CLARIFICATION/ COMPLIANCE REPORT

400 kV Switchyard at Panki Thermal Power Project (1 X 660 MW)

DRG. CABLE TRENCH LAYOUT OF 400kV SWITCHYARD (ELECTRICAL)

DRG NO. 9962-001-TB-572-PVE-F-190

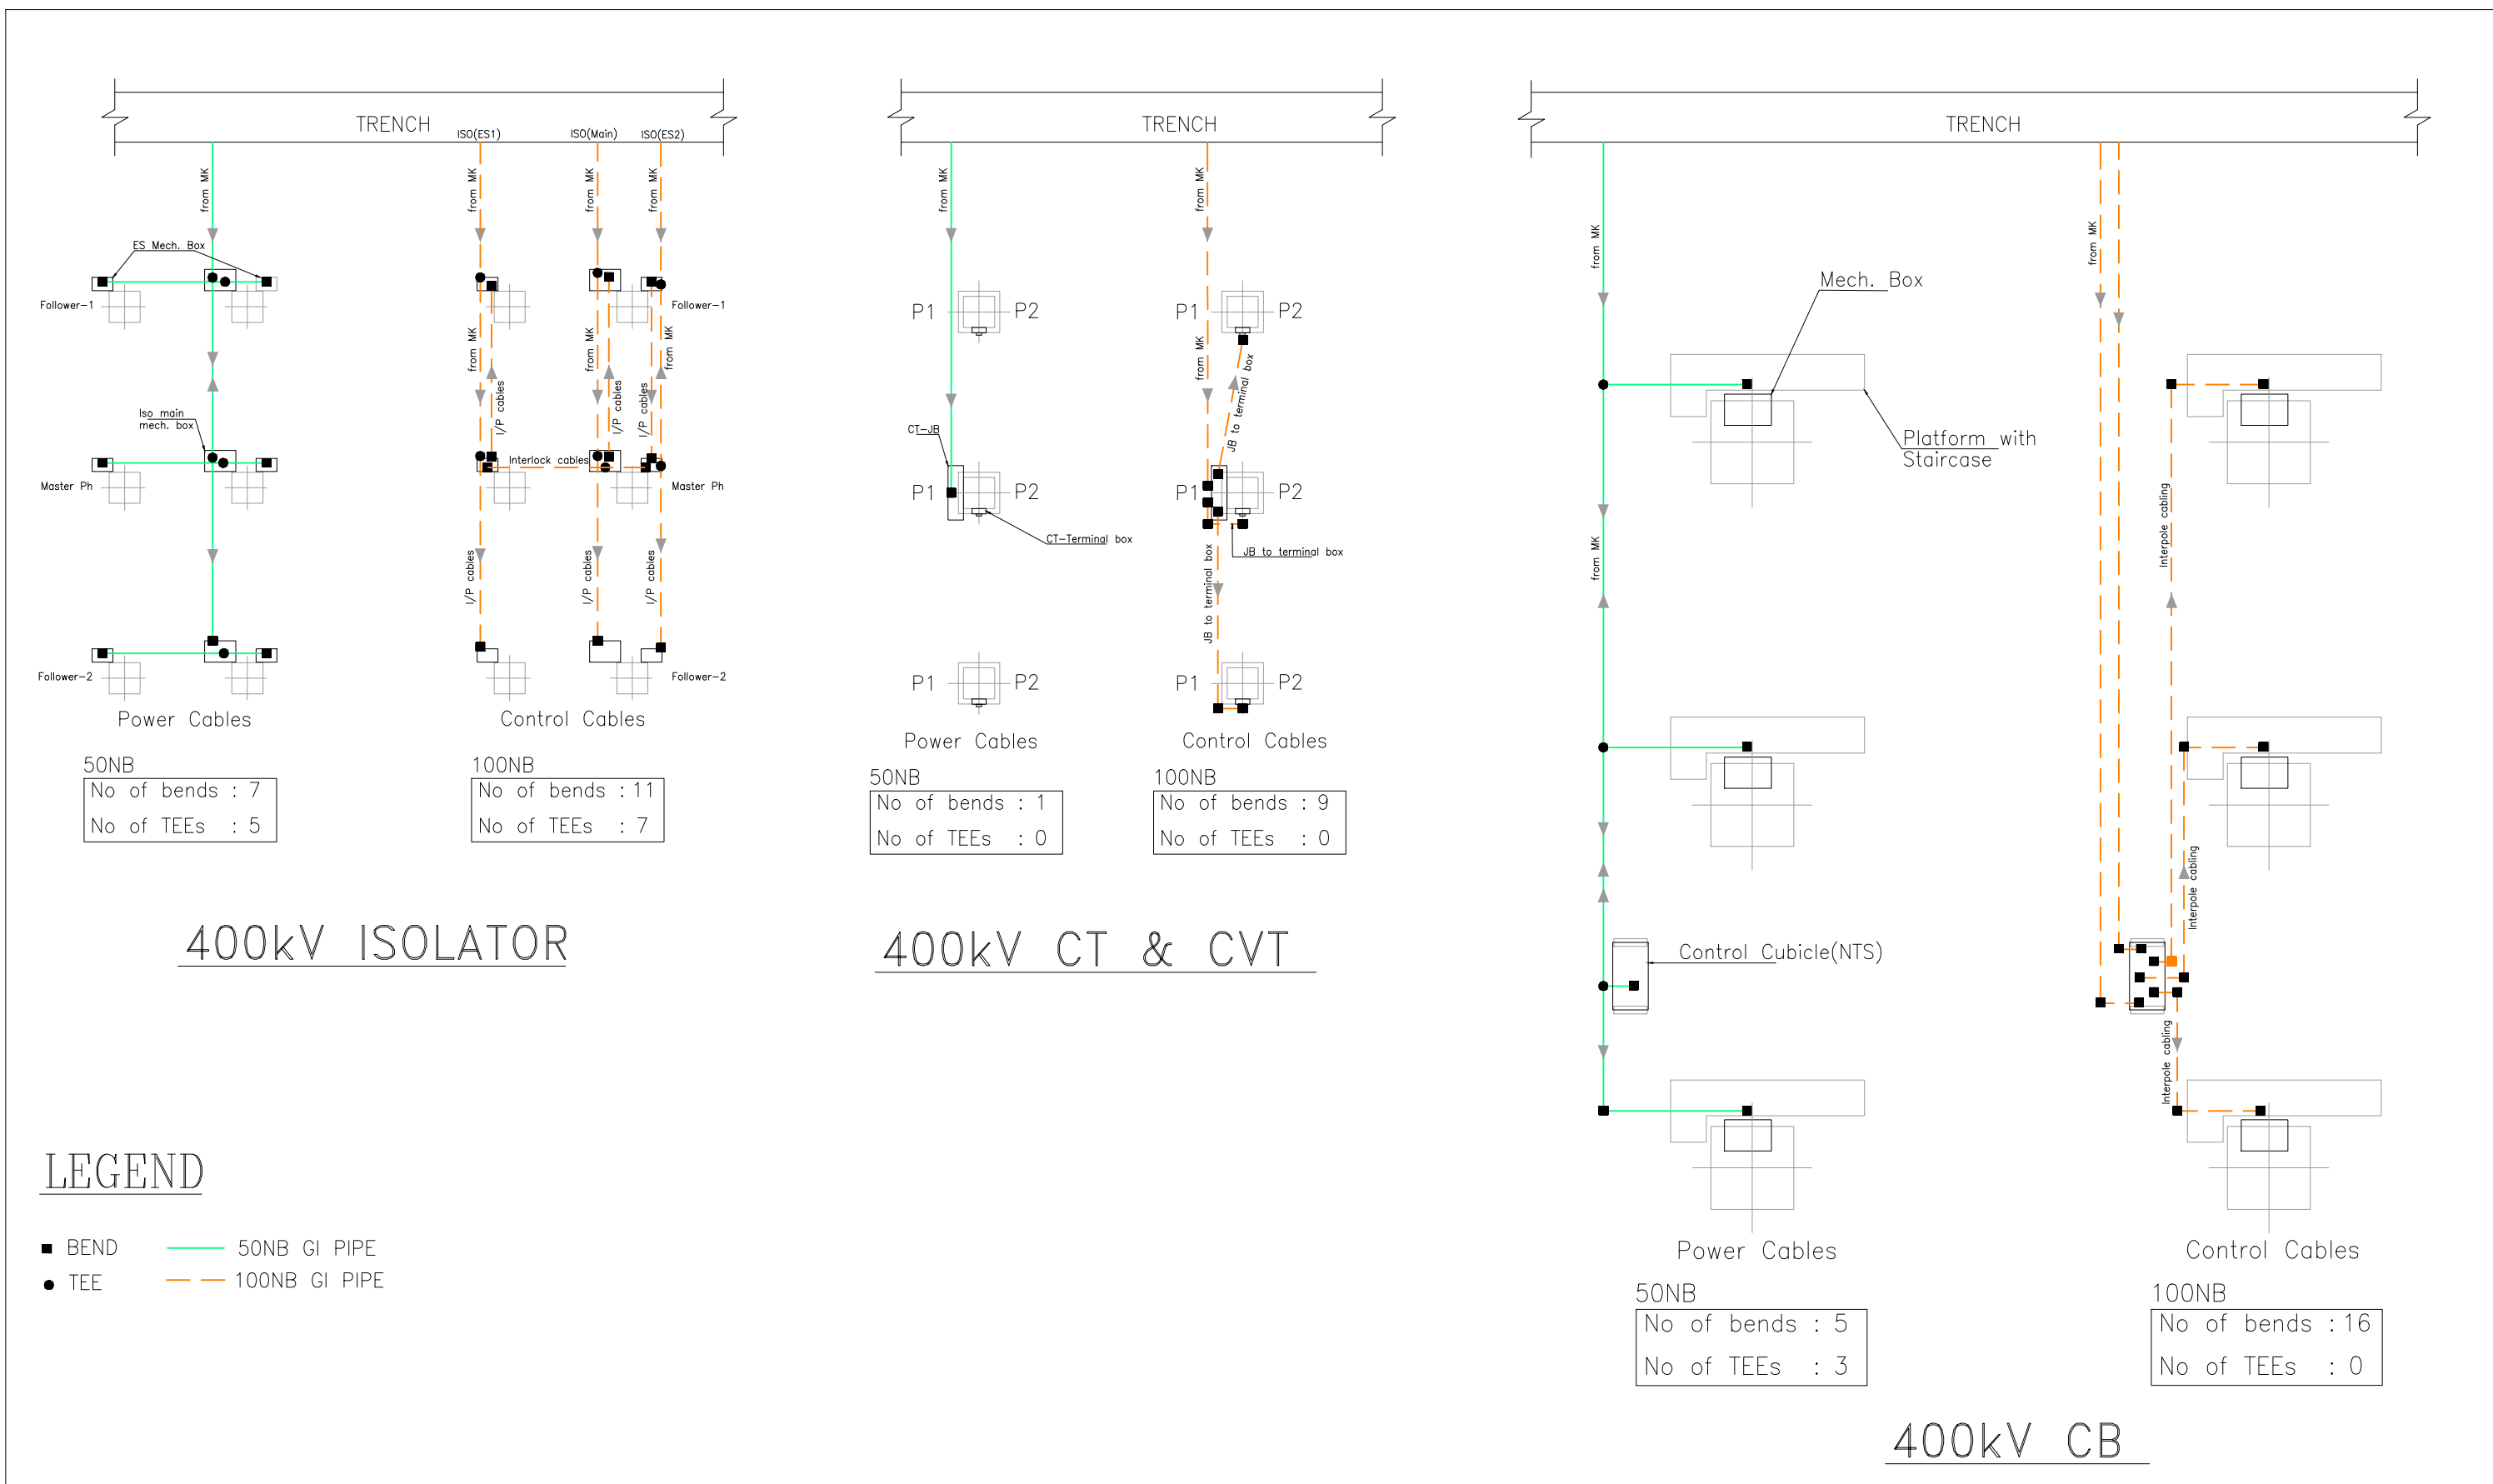
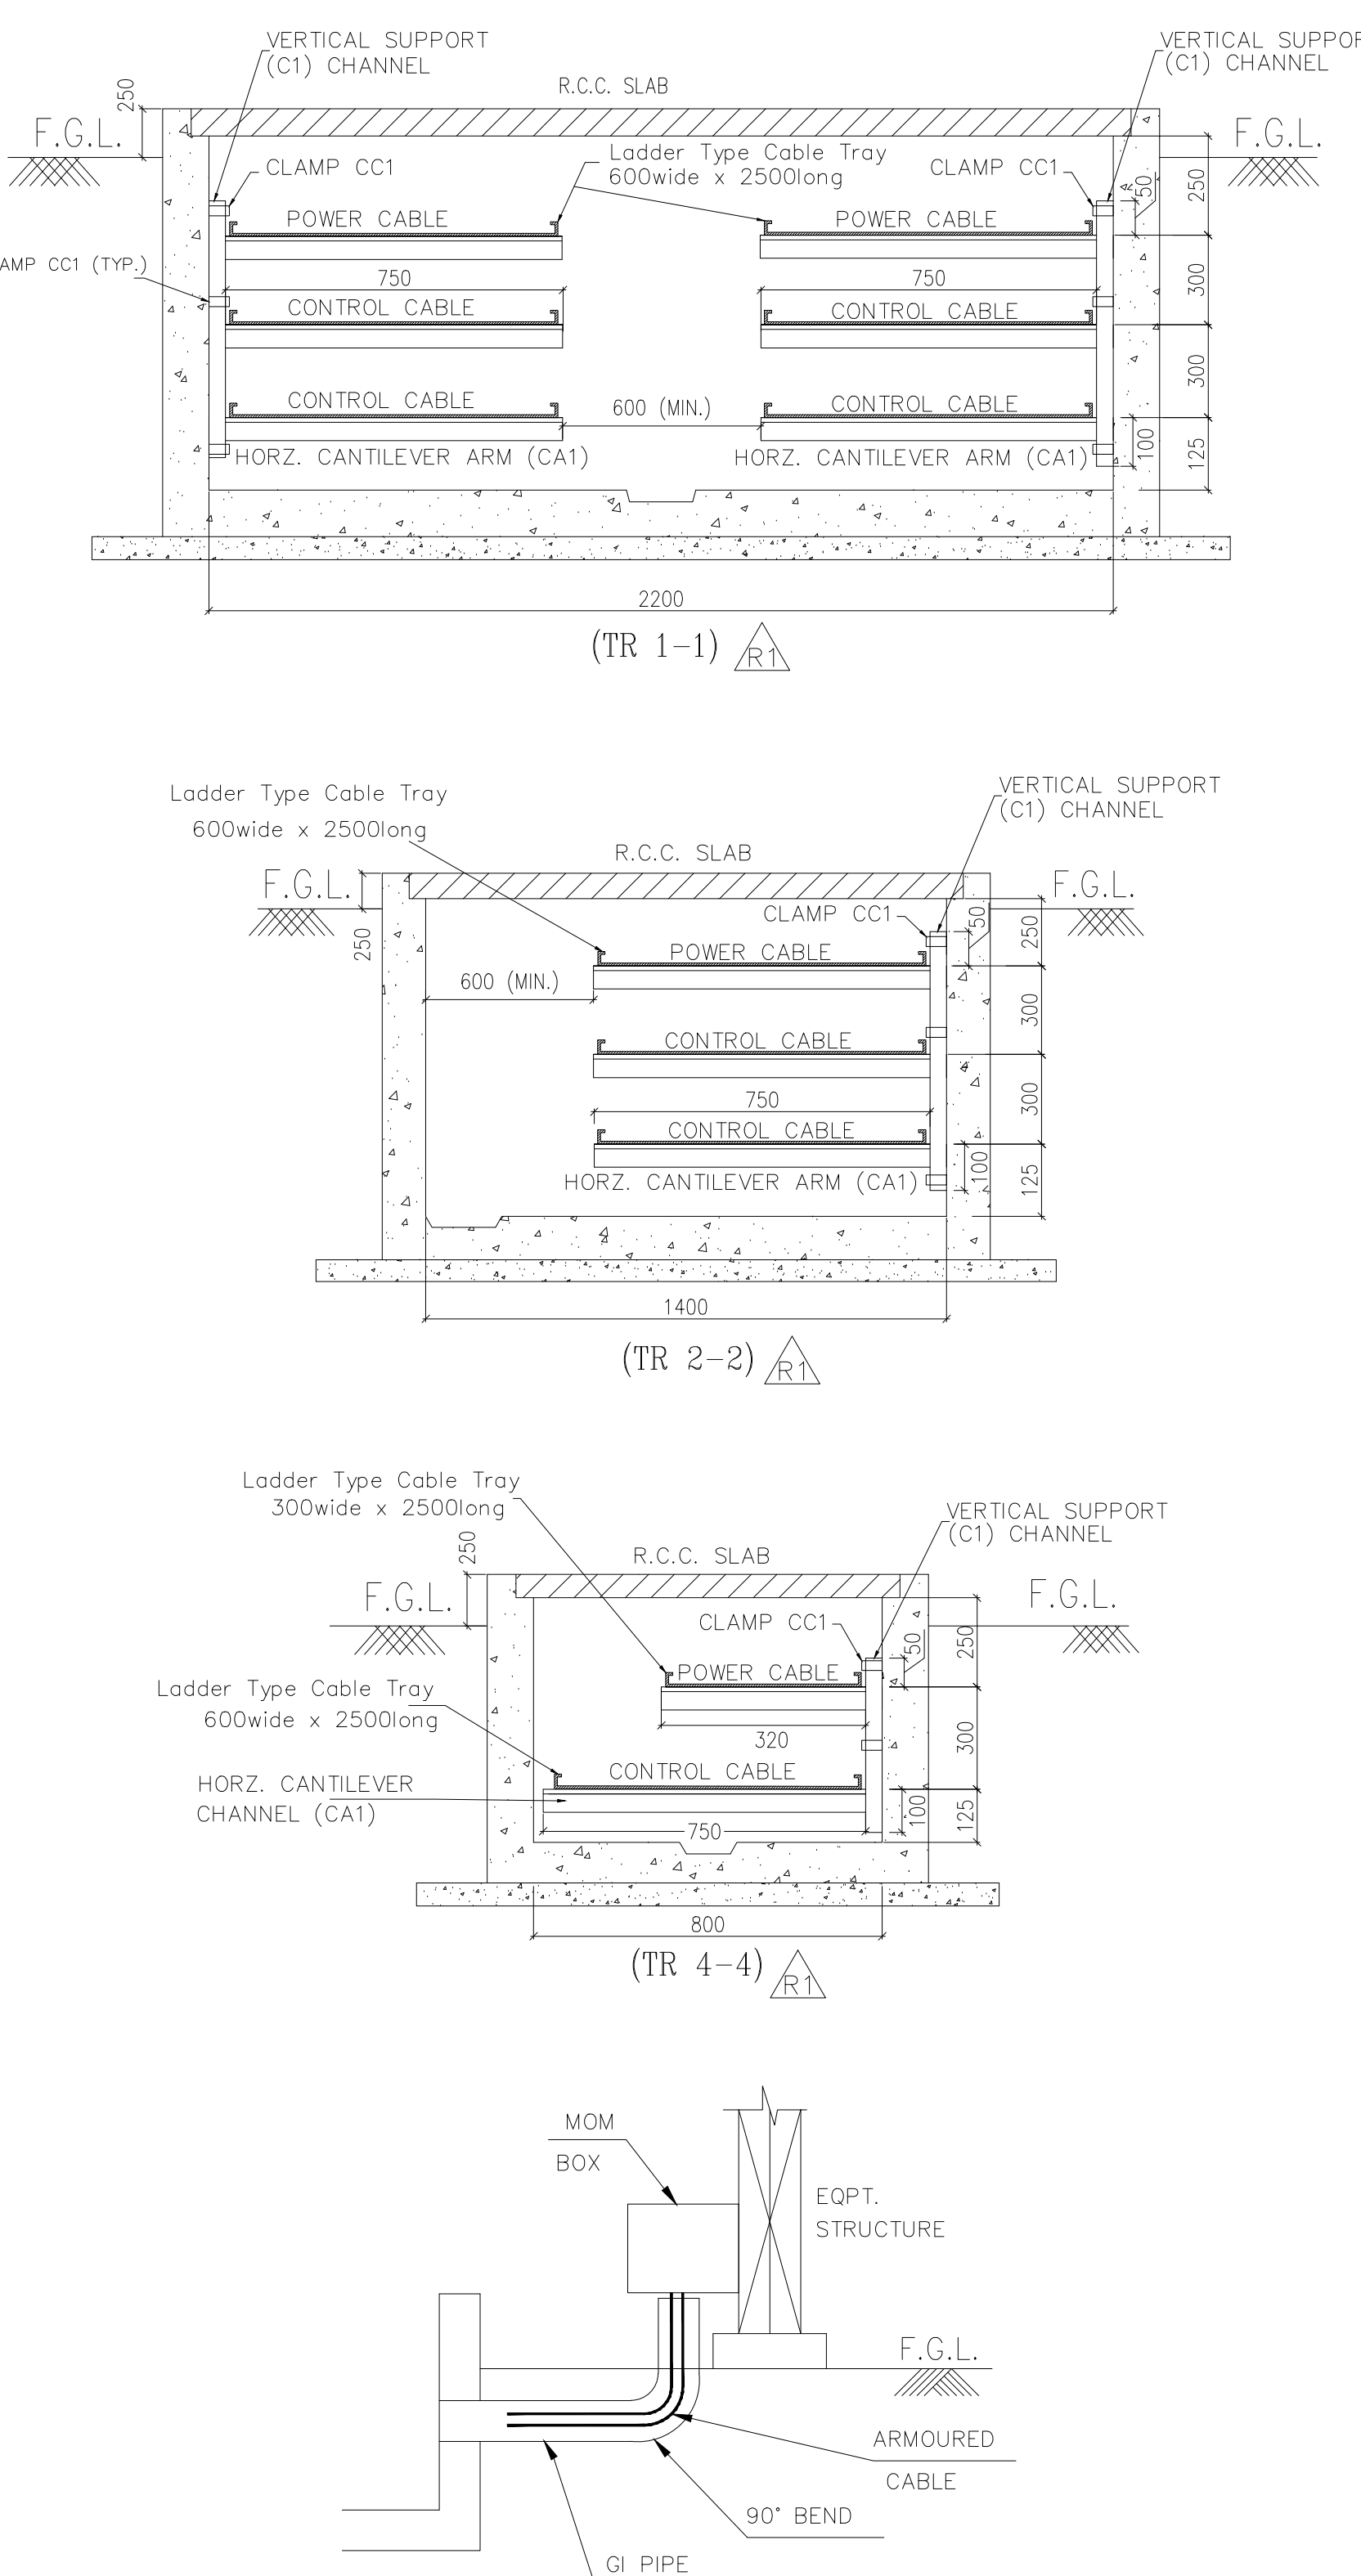
SL. NO.	NTPC/ Customer COMMENTS	BHEL COMPLIANCE/ CLARIFICATION
NTPC comments dtd. 31.07.19		
1	As per the Chapter-26 cabling system, The cable tray support arrangement shall be C1 / C2 channels , with cantilever arms. Change the tray arrangement accordingly .	Noted & incorporated. Bolted type arrangement is shown in the revised layout with rack assembly made up of channels C1. The revised arrangement is in line with the BHEL PEM document : "CABLE TRAY SUPPORT SYSTEM - DETAILS & DRAWINGS FOR CHANNELS, ARMS, BRACKETS AND OTHER HARDWARE. , DRG. NO.: 9962-001-PE-215-PVE-B-005"
2	1. SHOW LOCATION OF CABLE TRENCH SUMP PIT AND MARK REFERENCE TO CABLE TRENCH SUMP PIT DRAWING. 2. SHOW CABLE TRENCH CROSSING ROAD AND DRAWIN DETAILS OR MARK REFERENCE. 3. INDICATE LONGITUDINAL AND LATERA SLOPE OF CABLE TRENCHES. 4. MARK REFEREBCE TO INTERANAL AND EXTERNAL CABLE TRENCH SECTION DRAWING.	This document is electrical drawing (refer the document description in MDL) submitted for the purpose of getting approval of trench sections (width & no. of tiers) and route of trench. Based on approval of this layout, a separate civil document: "OVERALL FOUNDATION & CABLE TRENCH LAYOUT & SECTION DETAILS (CIVIL) DRG. No. 9962-001-TB-572-PVC-V-018" will be submitted. All the desired details (as asked in the comment) will be shown in the civil drawing. As this drawing is for the purpose of input to our civil group, kindly approve the same. We confirm that the all these comments will be incorporated in the separate civil drawing.

Additional changes done in layout of Switchyard		
1	Entry route in building revised to incorporate the increase in trench width (Section 1-1).	
2	Co-ordinate of CRB modified as per revised trench entry in building. Same shall also be reflected in revised Layout of Switchyard.
